LiDAR Quality Assessment Report

SD_Missouri River Lidar Dewberry_2016_D16 - Block3

NGTOC
2018-06-12
Sarah Klaas

Project: SD_Missouri River Lidar Dewberry_2016_D16 - Block3

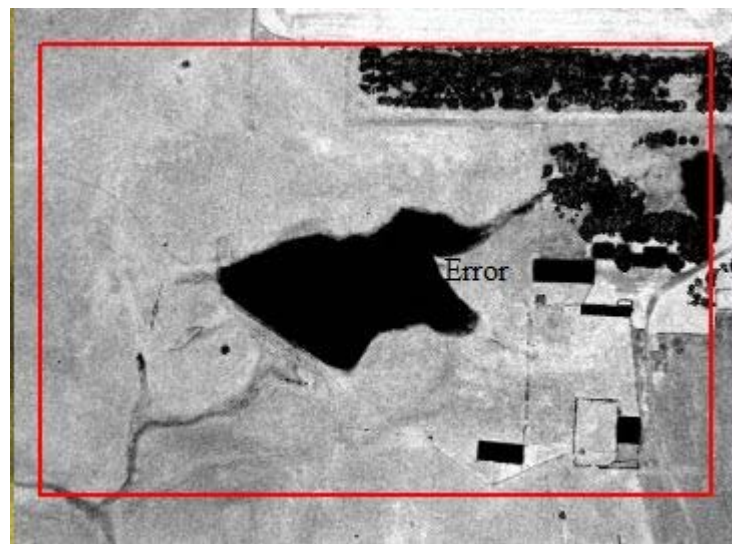
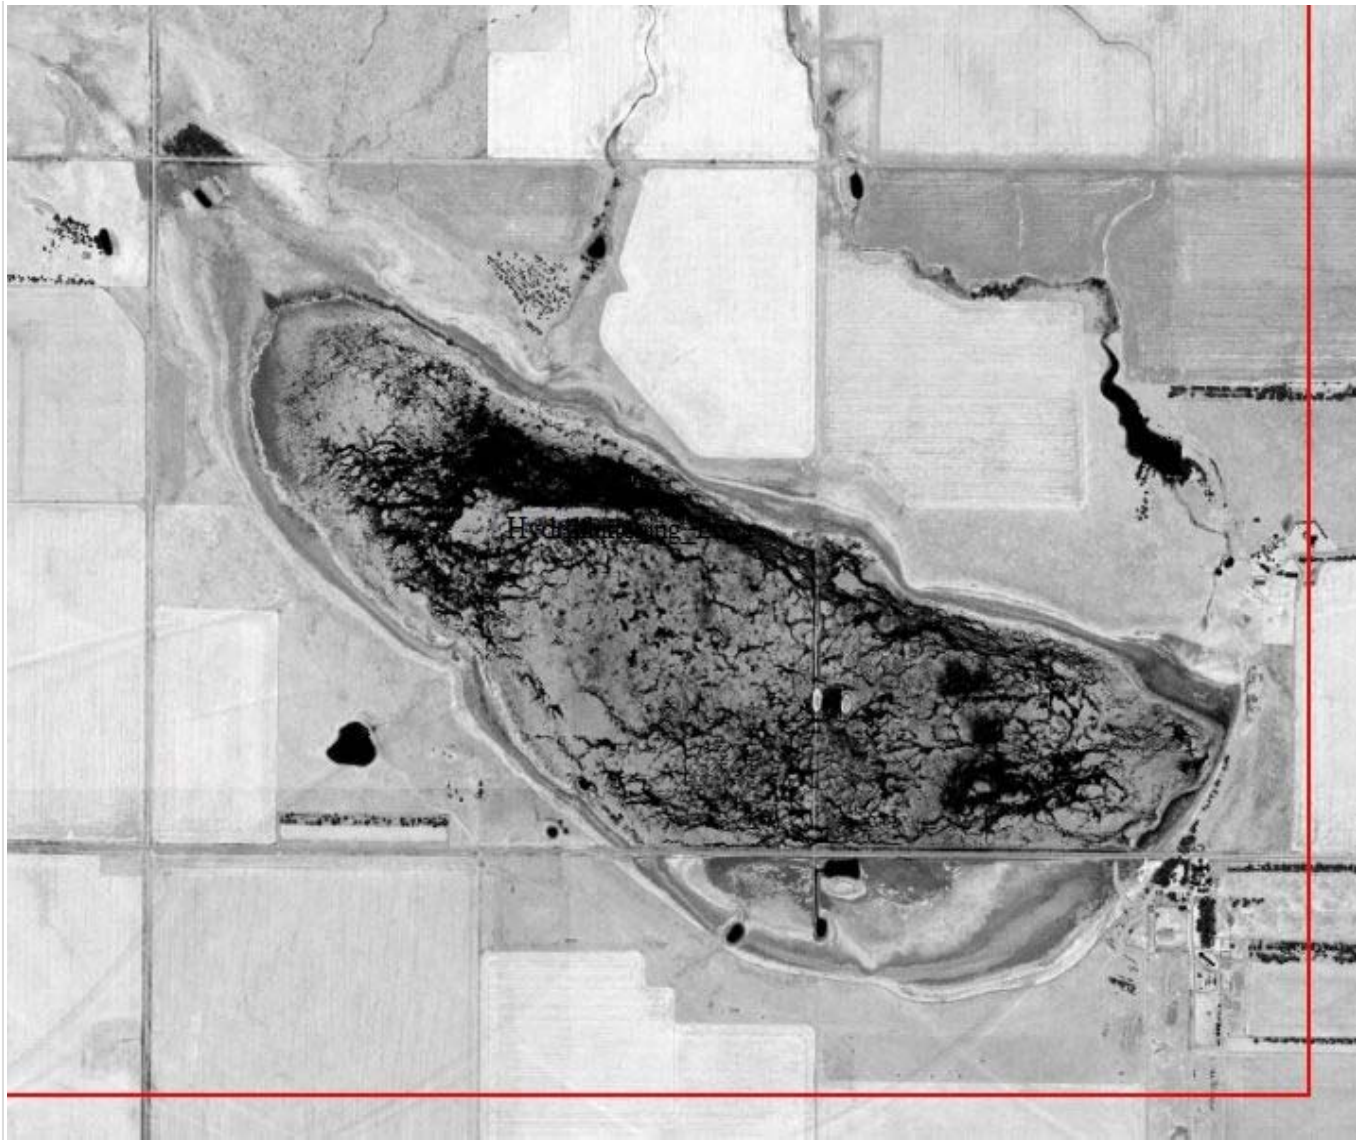
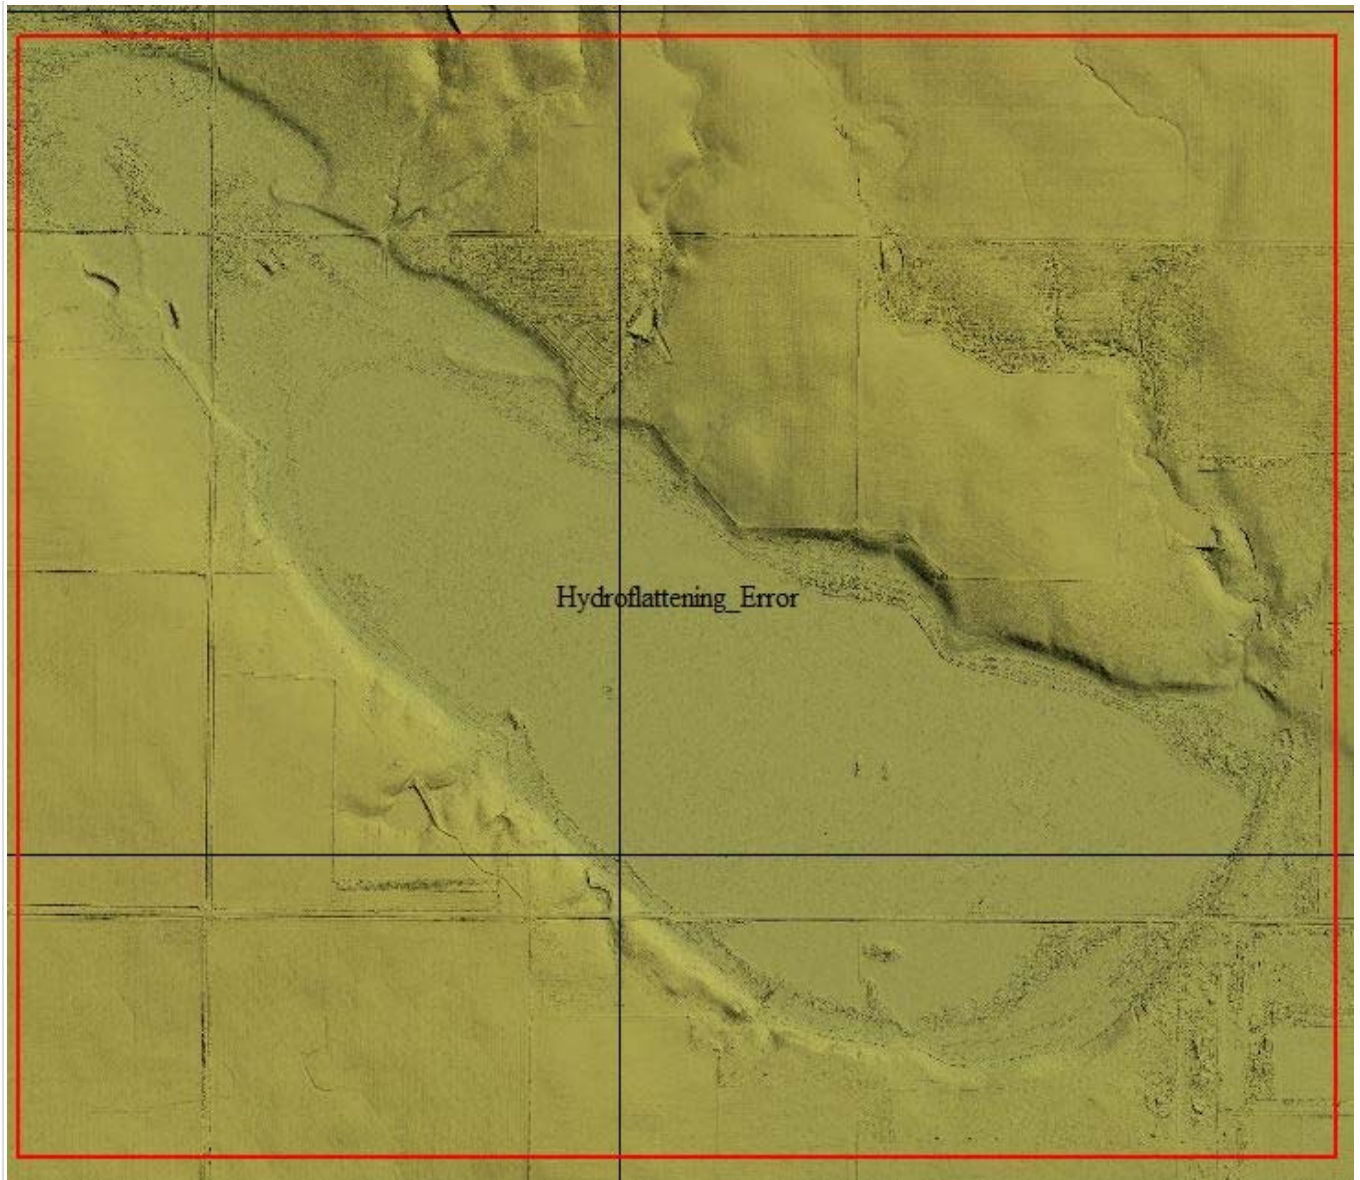
9 hydroflattening errors were found in block 3, waterbodies greater than 2 acres are not hydroflattened. Examples of this type of error can be seen below. (6/11/18)\

Corrected (9/18/2018)

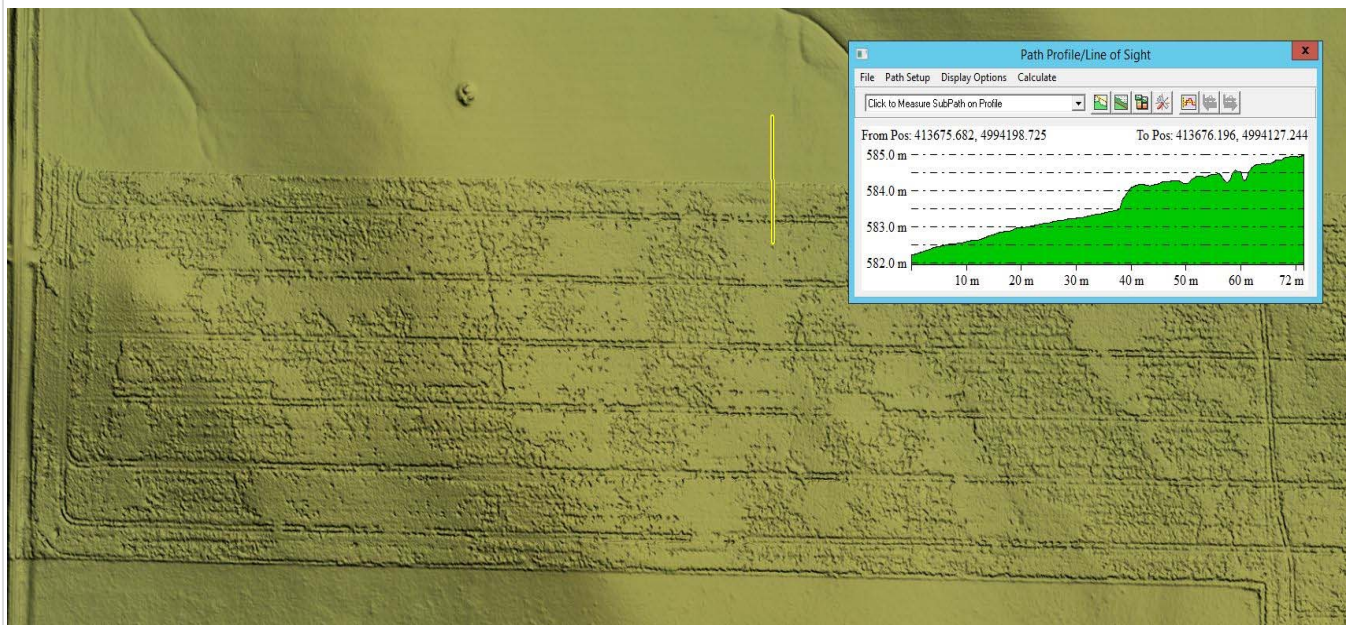
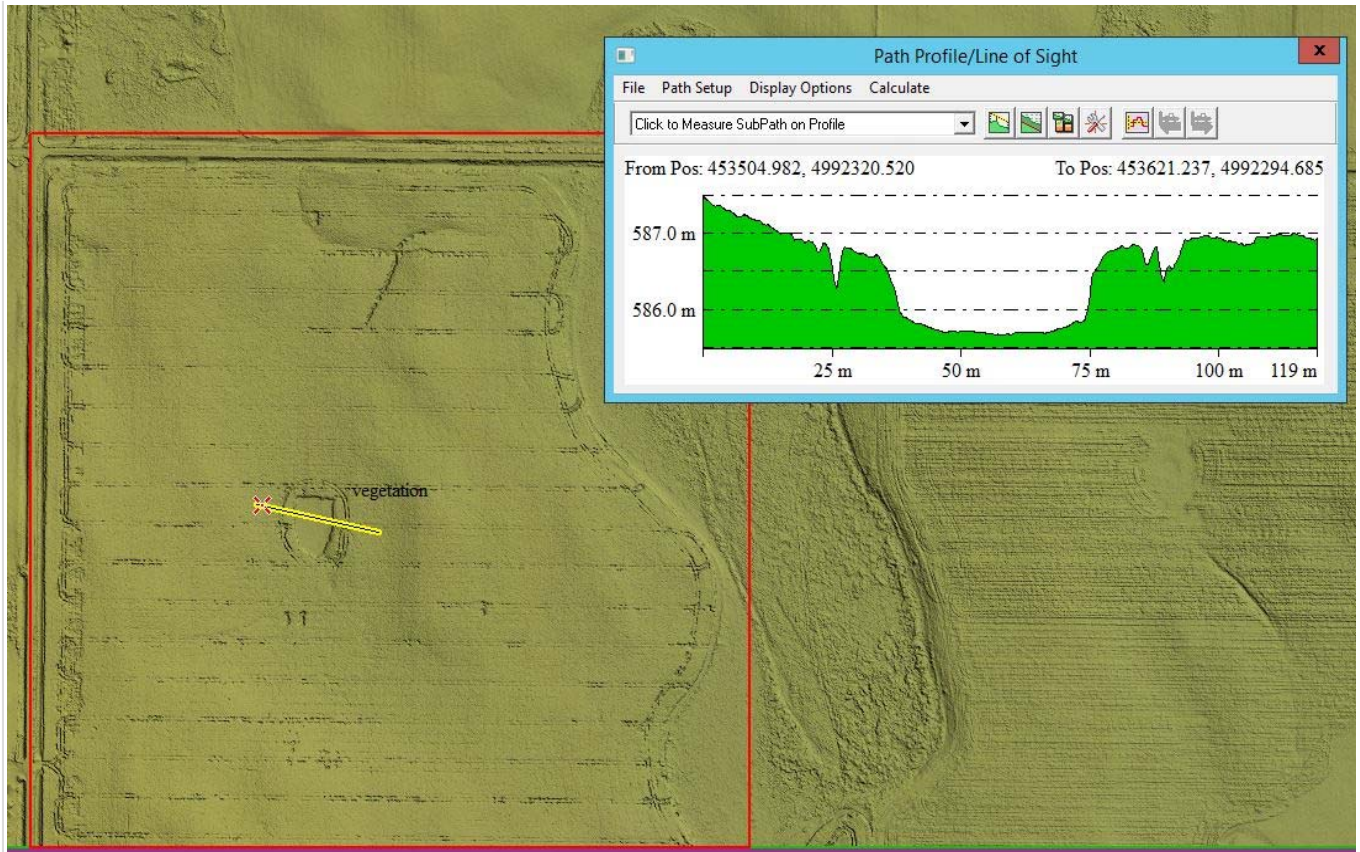
3 errors related to 1 meter tall vegetation in the DEM were found in Block 3, examples can be seen below. (6/11/2018) **Not Corrected (9/18/2018)**
